SERVICE BULLETIN

M-1408A

2014-2015 TOURING SADDLEBAG MOUNT - SAFETY RECALL 0166

Figure 1. Saddlebag Stud Receptacles

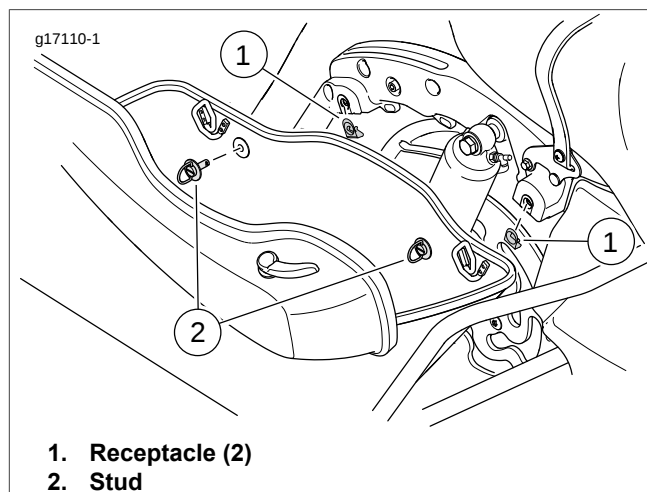
These model motorcycles built during the above date range may experience a failure of the saddlebag retaining receptacle. This may allow the mounting stud to disengage from the receptacle. If this condition remains undetected, the saddlebag may become separated from the motorcycle while it is in motion, possibly creating a hazard for other motorists.

- Kits required?: Yes.
- Kit wave shipments: Begin week of July 13, 2015 in limited quantities, which may require close usage management.
- Repair: All affected. No inspection required.
- Affected components: Part No. 10900009 Receptacle.
- Solution: Replace saddlebag receptacles.

1. Verify that the motorcycle is involved in this recall.
2. See Figure 1. Remove saddlebags.

3. Remove receptacles (1).
 - a. Insert a small screwdriver between receptacle clip and edge of saddlebag support.
 - b. Pry receptacle from saddlebag support.
4. Install **new** receptacles supplied in kit.
5. Install saddlebags using original studs (2) and washers.
6. When returning the motorcycle, remind the owner of the importance reading and following the saddlebag installation instructions provided in the owner's manual.
